# Caldecote PC Working Party East West Rail Report on Alignments 1 (Blue) & 9 (Purple)

# Working Party Evaluation and Conclusion

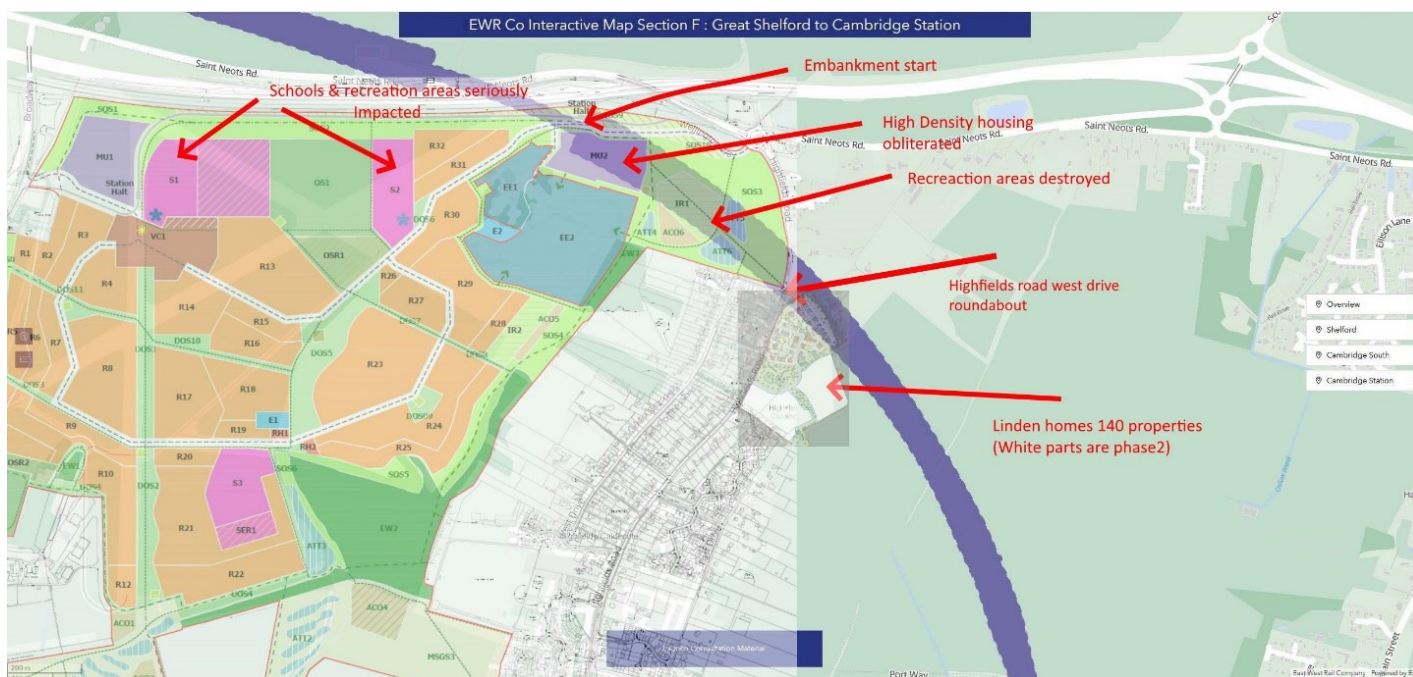
They have totally failed to take into account the impact on existing and planned developments when comparing alignments (1&9) to the alignments that use a South Cambourne Station (2,6 & 8).

Much is made of the apparently lower number of properties demolished on the blue alignment, but we calculate another 9+ properties in Linden Homes Angel Park development, and an extra 1 at Potts Farm, so without even considering the impact on Bourn Airfield development that makes it **14+ properties to be demolished on the 1&9 alignment, not 4!**

No real account has been made to the pollution, noise and visual impact on the inhabitants of West Drive, Highfields Road and Highfields Court of a 10-12m high, 80M wide, embankment. Having to go up an additional 10-12 meters on a hill that is already some 72M high has a disproportionate visual, noise and pollution impact on the surrounding area.

In addition, the wood and habitat behind Angel Park would need to be destroyed and further south of Toft and Cambourne alignments 1&9 means a loss of mapped priority habitat areas – **300% more** than routes 2&6.

Due to the proposed height and its impact on 2 communities the only sensible mitigation would be to tunnel under the A428.

Across the field it should be in a cutting below ground, just as is offered to the Broadway on alignments 2 & 6. This should extend to behind the woods at the back of Linden Homes' Angel Park.

Where it cuts Highfields Road and the track to Highfields Farm & its Public Right of Way, and the bridleway to Hardwick & Comberton, there should be bridges constructed over the cutting at ground level.

Pedestrian and cycling access should be offered by similar bridging across the field as per the paths detailed by the approved Bourn Airfield Development plan
